Subject: Revision to the Quality Assurance Plan for Shipping Program

BWXT Nuclear Operations Group, Inc., Lynchburg (NOG-L), forwards the enclosed Revision 21 to the Quality Assurance Plan for Shipping Program (QAP). This revision is submitted in accordance with the requirements of 10 CFR 71.106.

Quality Assurance Plan For Shipping Program

August, 2015
Rev. 21

Figure 1.1.1

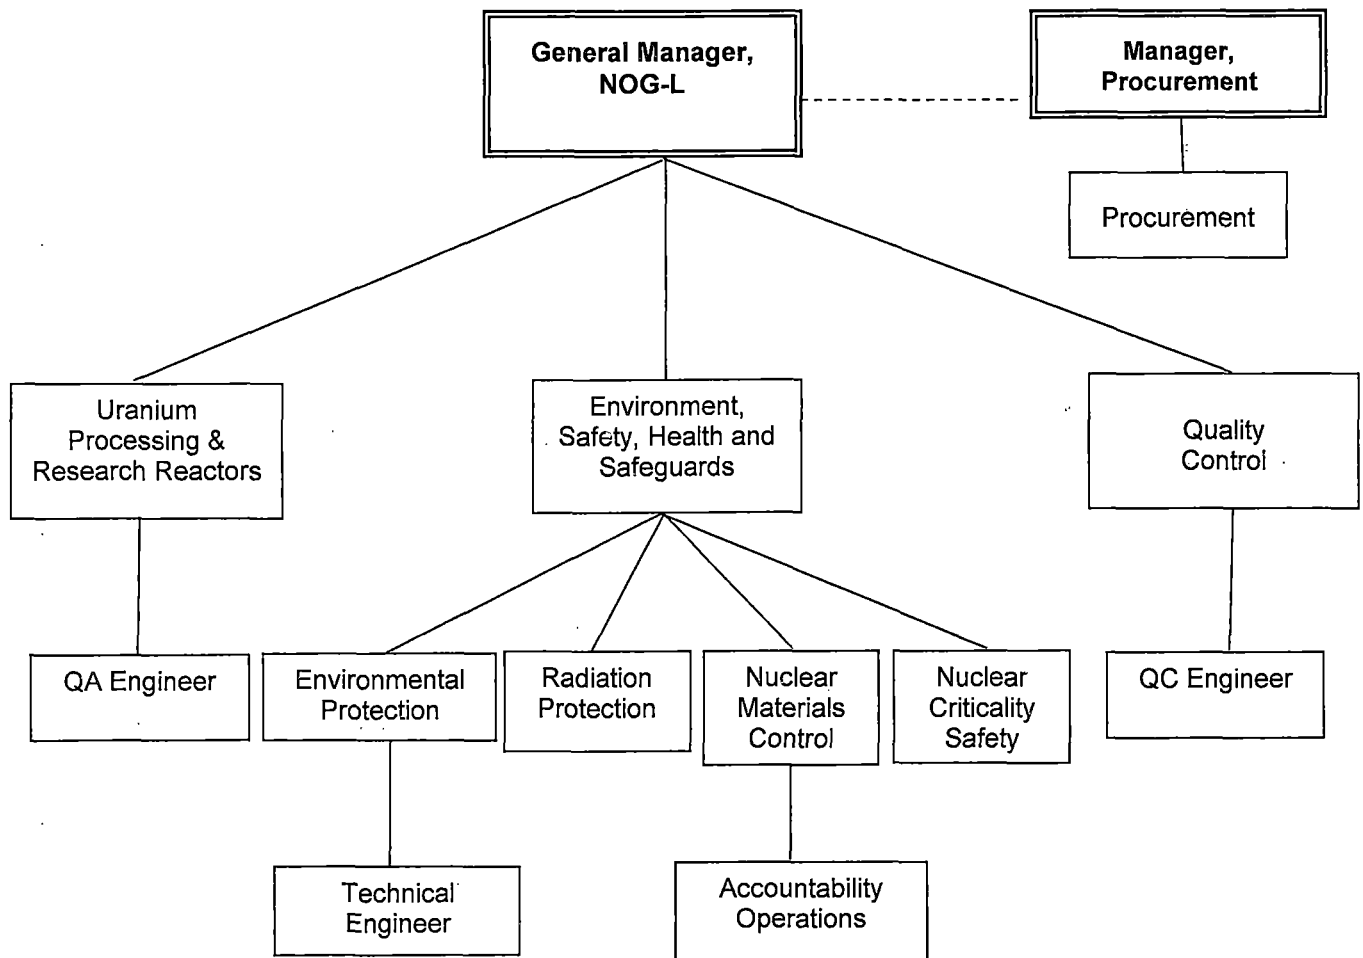
Section	Description of Change
Entire Document	Updated name change
Figure 1.1.1	Updated to show dotted line from General Manager to Procurement Manager
Table 1.2.1.1	Deleted OP-1008501 - OP-1001324 is the document used for inspection
